# UNITED STATES PATENT AND TRADEMARK OFFICE

APPLICATION NO.	FILING DATE	FIRST NAMED INVENTOR	ATTORNEY DOCKET NO.	CONFIRMATION NO.
10/622,660	07/21/2003	Takashi Yamaguchi	2018-743	3836

<b>Office Action Summary</b>	<b>Application No.</b>		<b>Applicant(s)</b>	
	10/622,660		YAMAGUCHI ET AL.	
	<b>Examiner</b>		<b>Art Unit</b>	
	Mr. Terry K. Cecil		1797

**DETAILED ACTION*****Claim Rejections - 35 USC § 103***

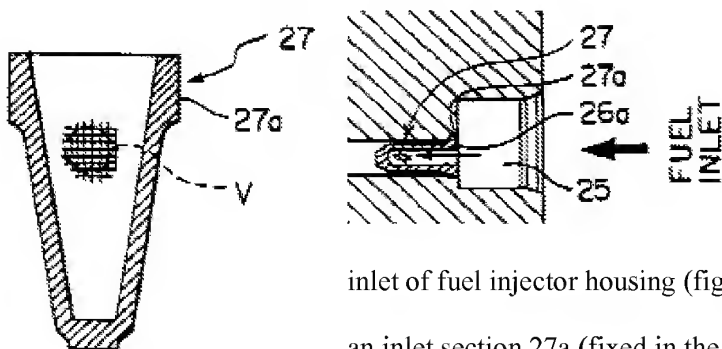
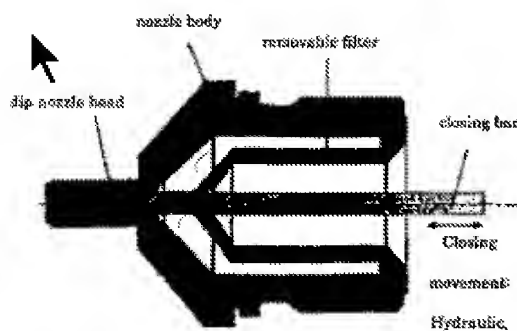
2. Claims 1, 3, 10-11, 17, 19-20, 22, 29-30, 35-38 are rejected under 35 U.S.C. 103(a) as being unpatentable over Isozumi et al. (U.S. 6,190,139 B1) in view of Verlag (US Publication XP-000766379). Isozumi teaches an injector comprising a

filter within a bore hole of an

inlet of fuel injector housing (figure 1). The filter 27 includes

an inlet section 27a (fixed in the peripheral surface of the

passageway of the bore hole), a closed end, and a filter section therebetween. The filter is

formed such that a tubular passage exists between the filter section and the inner surface of the

bore. Because of the shape of the sides of the closed end, the cross-sectional area between the

outer surface thereof and the inner surface of the bore (at the closed end) gradually increases in a downstream direction. Fluid enters through the opening of the inlet section, passes through an inside of the filter section, passes through the plurality of holes, and then flows through the tubular fluid passage toward a downstream of the tubular fluid passage. [as in claims 1, 10-11, 17, 20, 35 and 37]. Since the high pressure pump (and the filter) is connected to an injector (as taught in col. 3 lines 45-52), the injector can be said to “comprise” the filter and the housing thereof, as claimed. The end is considered to be *approximately* conically-shaped, the diameter thereof increasing in a fluid flow direction [as in claim 3].

However, Isozumi fails to explicitly disclose a tubular fluid passage that has a cross-sectional area equivalent to or smaller than a summation of cross sectional areas of the holes at every point along the length of the filter section (claims 1 and 11); or at a point downstream of the most downstream one of the holes of the filter section, the tubular fluid passage having a cross-sectional area that is equivalent to or smaller than a summation of cross-sectional areas of all of the holes of the filter section (claims 35 and 37). However, such is made obvious by Verlag (XP-000766379):

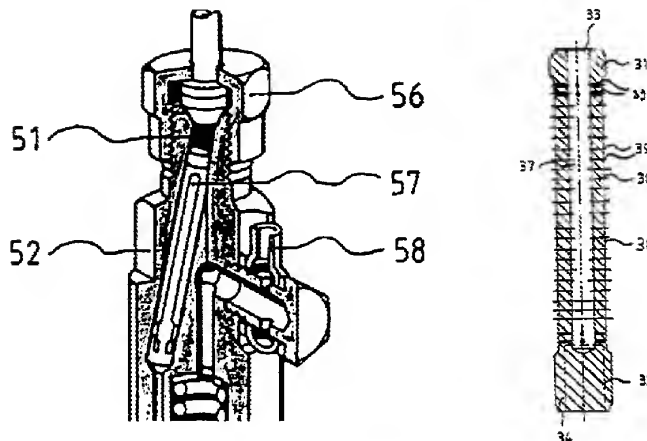
Verlag teaches filter apertures to have a total cross-sectional area that is considerably greater than the borehole of the machine nozzle in order to reduce *to a minimum* the pressure loss across the filter (as a result, all cross-sections of the tubular passage are necessarily smaller than the total filter aperture areas) [as in claims 1, 10-11, 17, 19-20, 22, 29-30, 35-38]. In order to have *a minimum pressure loss*, the skilled man would understand the borehole of which Verlag speaks to be the entire borehole passage through the nozzle body. (The filter having a total aperture open area smaller than any flow cross-section through the nozzle would NOT minimize the pressure loss). The total cross-section of the filter boreholes is larger than all cross-sections of the borehole passage through which the fluid flows. It would have been obvious to one of ordinary skill in the art at the time of the invention to modify Isozumi in view of Verlag (XP-000766379), since Verlag teaches the benefit of minimizing the pressure loss at high velocities of supplying the solution.

Also, since the amount of fluid allowed through the tubular flow passage depends upon the cross-sections thereof, the passage has a structure that allows it to perform the function of regulating the flow therethrough.

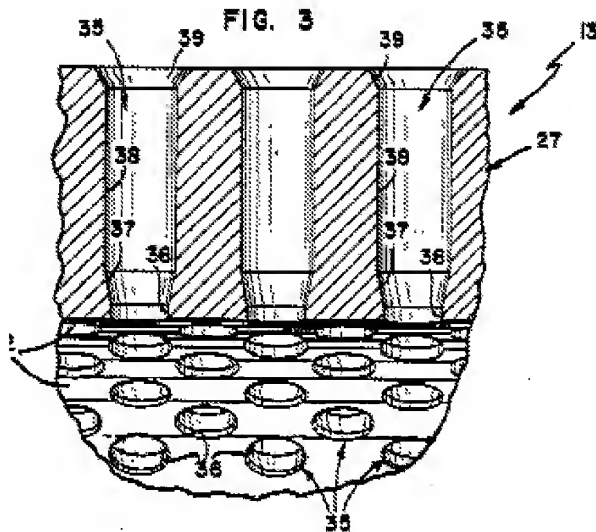
**In the case of all of the illustrated exemplified embodiments the entire orifice cross-section of all orifices disposed in the filter element is larger than or equal to the cross-section of the fuel duct.**

The filter is placed in the fuel duct of an injector—as described in e.g. his claim 1.

It is considered that it would have been obvious to one ordinarily skilled in the art at the time of the invention to have the entire cross-section of all the orifices of the filter section of '316 to be larger than the cross section of the fuel duct as taught by '571, since '571 teaches the benefit of the slightest possible flow resistance against the fuel (page 5, last line to page 6, line 4).
